Our Ref: STH05/00332/06

Your Ref: DA404-11-2022-I-MOD-14 (PAE-40884867)

**DA404-11-2022-I-MOD-14, BERIMA CEMENT WORKS MODIFICATION, LOT: 1 & 22 DP: 582277 & LOT: 2 DP: 774598 & LOT: 100 DP: 882139, TAYLOR AVENUE, NEW BERIMA**

## Proposed Conceptual Intersection Design

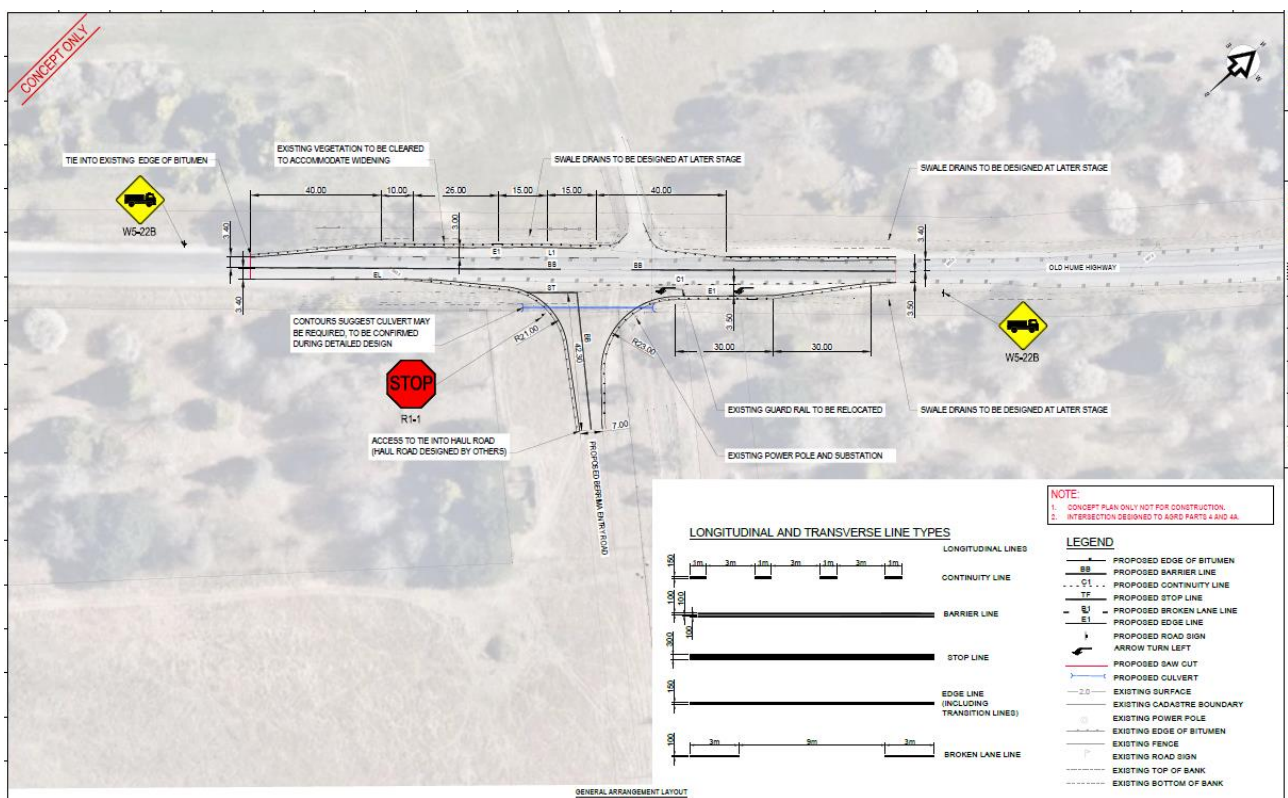
1. TIA represents a BAR and AUL(s) solution as part of the proposed intersection treatment of the new haul road with the Old Hume Highway. The following points are raised for advice:

- TfNSW has undertaken a brief review of the design of the AUL(s) which has currently identified that there are deficiencies in the design (for example, the length of the deceleration lane and taper length of the AUL(s), and the width of the BAR treatments do not correlate to the requirements of Austroads Guideline - Part 4a).

- TfNSW also advise that the current deficiencies in the TIA as raised in points 2 to 4 of this letter above may impact the warrants for treatments that are required for this intersection. That is, treatments based upon the 80km/hr speed environment and warrants diagram provided in Austroads Part 6, may require a higher order treatment than currently represented in the TIA.
